NRC Staff Comments on: “Industrial Wastewater Closure Module For The Liquid Waste Tanks 5F and 6F F-Area Tank Farm, Savannah River Site,” SRR-CWDA-2012-00071, Revision 0, January 2013

NRC staff offers the following public comments to SCDHEC to provide insight regarding aspects of tank cleaning, waste sampling, and characterization of residual contaminants that will be important to NRC staff in its role of monitoring DOE’s ability to comply with the performance objectives of 10 CFR Part 61, in particular, the ALARA aspect of 10 CFR 61.41:

Figure 3.1-32 (page 46) of SRR-CWDA-2012-00071, Rev. 0.

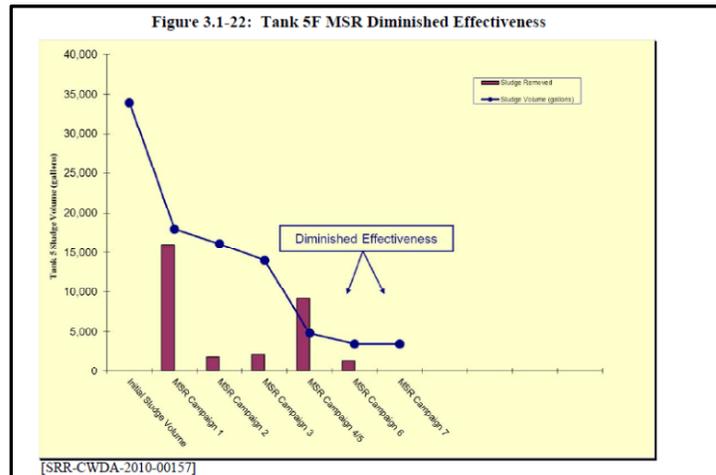
1. SRR-CWDA-2012-00071, Rev. 0 (page 41) discusses the effectiveness of a 3rd SMP installed under Riser 1 in MSR Campaign 4 and 5. It is not clear why the addition of the 3rd SMP under Riser 1 was not as effective in MSR Campaign 3 and suddenly became effective essentially in MSR Campaign 5 (Campaign 4 was curtailed due to a tornado watch). See figure below. It would be helpful for DOE to comment on the uncertainty in the heel estimates and if the uncertainty could partially explain the relative effectiveness of MSR Campaign 5 compared to Campaign 3. Any additional insights on the increased effectiveness of Campaign 5 compared to Campaign 3 would be helpful.
